Chancellor Garments Ltd. (relocated)

295/JA/4/A, Rayer bazar, Dhaka-1209, Bangladesh.

7 March 2024

2. Observations:

Building-1

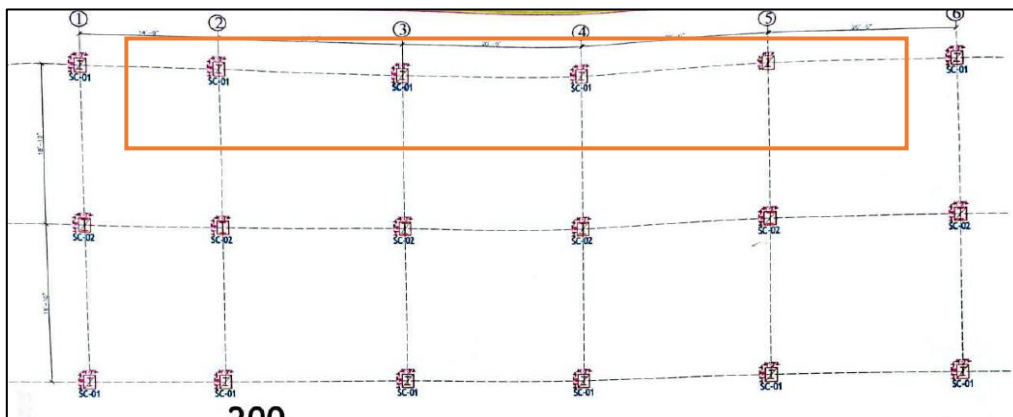
Observation 2: Absence of design documents. (Building-1)

Description: As per BNBC, every building or structure designed shall have its design documents prepared in accordance with the provision of Section 1.9.1. The design document shall include a design report, and a set of structural drawings, which shall be prepared in compliance with section 1.9.1.1 and section 1.9.1.2 as per BNBC. At the time of inspection, design report was not available which is required to be prepared in compliance with BNBC.

Building-2

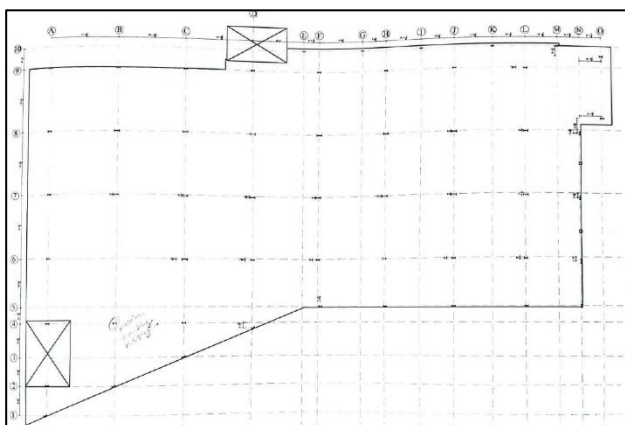
Observation 6: Absence of design documents. (Building-2)

Description: As per BNBC, every building or structure designed shall have its design documents prepared following the provision of Section 1.9.1. The design document shall include a design report, and a set of structural drawings, which shall be prepared in compliance with section 1.9.1.1 and section 1.9.1.2 as per BNBC. At the time of inspection, a design report was not available which is required to be prepared in compliance with BNBC.

Column Layout plan

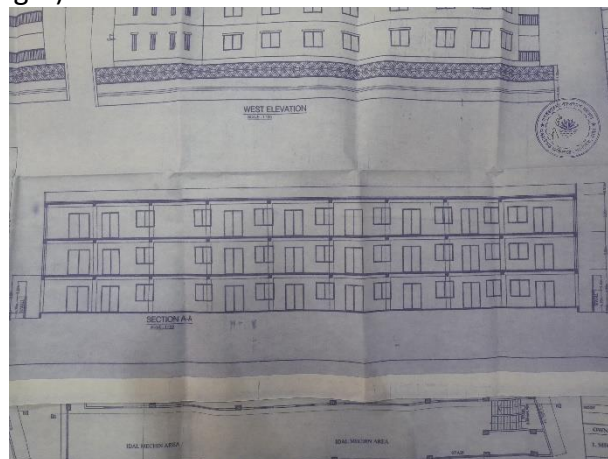
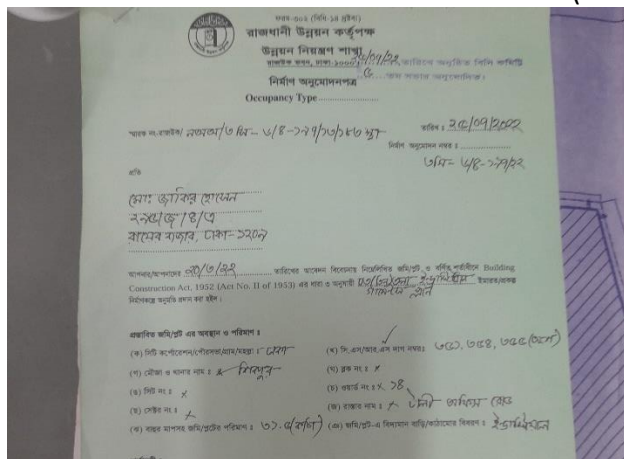
Observation-7: Lack of information in as-built drawing. (Building-3)

Description: During the inspection, only the sub-structure drawing for Building 3 was available. The building engineer is required to prepare a full set of as-built drawings incorporating both substructure and superstructure and all details of this Building.
